APPLICATION NO.	FILING DATE	FIRST NAMED INVENTOR	ATTORNEY DOCKET NO.	CONFIRMATION NO.		
10/517,248	06/20/2005	Mikio Miyake	MICS124074	2899		
26389	7590	07/28/2008	EXAMINER			
CHRISTENSEN, O'CONNOR, JOHNSON, KINDNESS, PLLC 1420 FIFTH AVENUE SUITE 2800 SEATTLE, WA 98101-2347				KIANNI, KAVEH C		
ART UNIT		PAPER NUMBER				
2883						
MAIL DATE		DELIVERY MODE				
07/28/2008		PAPER

Office Action Summary	Application No.	Applicant(s)	
	10/517,248	MIYAKE ET AL.	
	Examiner	Art Unit	
	K. Cyrus Kianni	2883

Claims 1 and 20-25 are rejected under 35 U.S.C. 103(a) as being unpatentable over Cartier (US 4767177).

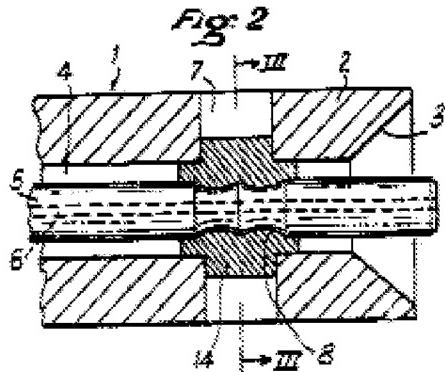
Cartier teaches a pair of ferrules used for an optical fiber connector (shown in at least fig. 10, items 1 and 12), the pair of ferrules 1 comprising:

a first ferrule which has an optical fiber-inserting hole and an end portion (see col. 5, 4th parag.); and a second ferrule which has an optical fiber-inserting hole and an end portion (shown in at least fig. 1, items 2 and 3),

said optical fiber-inserting hole of the second ferrule is substantially the same diameter as the optical fiber-inserting hole of the first ferrule and is arranged opposingly to the first ferrule so that the optical fiber-inserting hole of the second ferrule is positioned coaxially with respect to the optical fiber-inserting hole of the first ferrule (shown in at least fig. 2, ferrules 2 and 3 having the same optical fiber insertion diameter),

the end portion of the first ferrule is opposed to the second ferrule, and has a male convex shape extending to the end of the first ferrule end portion (see at least fig. 2), and the end portion of the second ferrule is opposed to the first ferrule, and has a female concave shape provided with a fitting section for receiving the end portion of the male convex shape while making tight contact therewith (see fig. 2 and 1). wherein each of the first and second ferrules is made of metal (see col. 1, 3rd parag.); wherein each of the first and second ferrules is made of stainless steel; wherein each of the first and second ferrules is produced by an electroforming method (not given patentable weight for process used to obtain the ferrule).

However, Cartier does not specifically teach the above limitations in a single embodiment and that the above convex shape part of the connector is male and has an angle of depression of 20.degree. to 80.degree and that the material of the ferrule is nickel alloy. It would have been obvious to a ordinary skilled I in the art when the invention was made to modify an embodiment of Cartier by combining it with its second/another embodiment in which they are closely compatible and as a matter of desired design to have the angle range such as 20 degree to 80 degree and that the metallic ferrule as matter of design choice be nickel and/or steel alloy since such shape

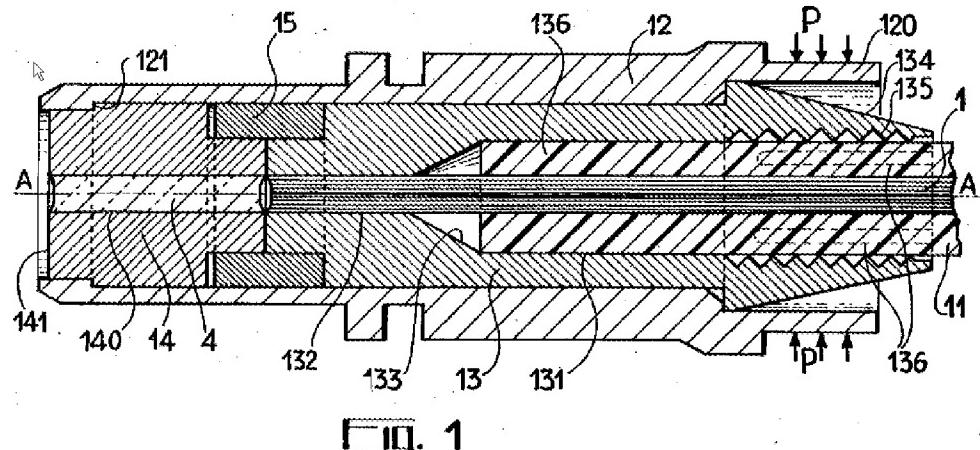
Bouygues teaches a pair of ferrule used for an optical fiber connector (shown in at least fig.1, see at least abstract and col. 2, lines 43-64);

a first ferrule which has an optical fiber-inserting hole and an end portion (see col. 5, 4th parag.); and a second ferrule which has an optical fiber-inserting hole and an end portion (shown in at least fig. 1, items 2 and 3),
said optical fiber-inserting hole of the second ferrule is substantially the same diameter as the optical fiber-inserting hole of the first ferrule and is arranged opposingly to the first ferrule so that the optical fiber-inserting hole of the second ferrule is positioned coaxially with respect to the optical fiber-inserting hole of the first ferrule (shown in at least fig. 2, ferrules 2 and 3 having the same optical fiber insertion diameter),

the end portion of the first ferrule is opposed to the second ferrule, and has a male convex shape extending to the end of the first ferrule end portion (see at least fig. 1 and 3), and the end portion of the second ferrule, which is opposed to the first ferrule, has a female concave shape provided with a fitting section for receiving the end having the convex shape while making tight contact therewith (shown in at least fig. 1, items 13 and conical item 133); that wherein each of the convex/concave shape has one of a conical/spheroidal/hemispherical shape (see fig. 1); wherein each of the first and second ferrules is produced by an electroforming method (not given patentable weight for process used to obtain the ferrule).

However, Bouygues does not specifically state that the above covex shape part of the connector is male and has an angle of depression of 20.degree. to 80.degree and that the material of the ferrule is metal/stainless-steel/nickel -alloy It is obvious/well-known to those of ordinary skill in the art when the invention was made that matching shapes is being inserted into the a segment counterpart is a male and that it would have been obvious to a person of ordinary skill in the art when the invention was made as a matter of desired design to have the angle range such as 20 degree to 80 degree and that the ferrule material to be extremely conventional metals such as nickel and/or steel alloy since such shape provide longer duration without reducing in thermal and mechanical property in high temperature and humidity circumstances and being able to efficiently plugged together (see col. 1).
